Access Compliance Report

Public Rights-of-Way

(Curb Ramps)

Intersection ID: 48435	Main Street: BEDLINGTON_RD	Cross Street: SEAMILL_RD	Location: NE
ADA ID: 2337EA49DDBE	Ramp Type: PerpDiag	Initial Pass/Fail: Fail	Overall Compliance: No
		Severity Score: 8.75

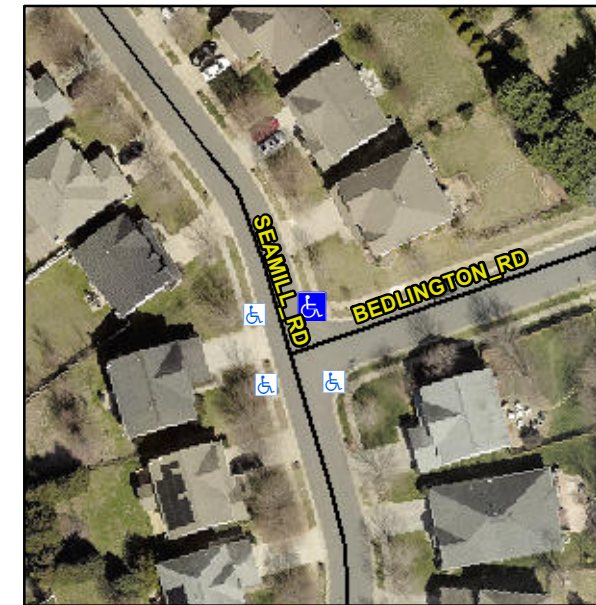
Not Found, R304.5.1

Compliance	Description	Data	Compliance	Description	Data
N/A	Ramp Length (in)	47.0	Yes	Ramp Slope (%)	6.2
No	Ramp Width (in)	47.0	Yes	Ramp XSlope (%)	0.7
N/A	Flare Type LT	N/A	N/A	Flare Type RT	N/A
N/A	Flare Slope LT (%)	N/A	N/A	Flare Slope RT (%)	N/A
N/A	Flare Traversable LT?	N/A	N/A	Flare Traversable RT?	N/A
N/A	Landing Length (in)	N/A	N/A	DWS Provided?	N/A
N/A	Landing Width (in)	N/A	N/A	DWS Contrast?	N/A
N/A	Landing Slope (%)	N/A	N/A	DWS Length (in)	N/A
N/A	Landing X Slope (%)	N/A	N/A	DWS Full Width?	N/A
N/A	Landing Curb? (Y/N)	N/A	N/A	DWS Offset (in)	N/A
N/A	Shared Landing?	N/A			
N/A	Gutter Ponding?	N/A	N/A	Gutter Slope (%)	N/A
N/A	Gutter Lip Ht (in)	N/A	N/A	Gutter X Slope (%)	N/A
N/A	Painted X Walk1?	No	N/A	Painted X Walk2?	No
	X Walk 1 Direction	To W		X Walk 2 Direction	To S
N/A	X Walk 1 Width (in)	N/A	N/A	X Walk 2 Width (in)	N/A
	X Walk 1 Slope (%)	3.3		X Walk 2 Slope (%)	0.1
	X Walk 1 X Slope (%)	0.9		X Walk 2 X Slope (%)	0.5

Remove & Replace Curb Ramp With Two New Directional Ramps or Equivalent.
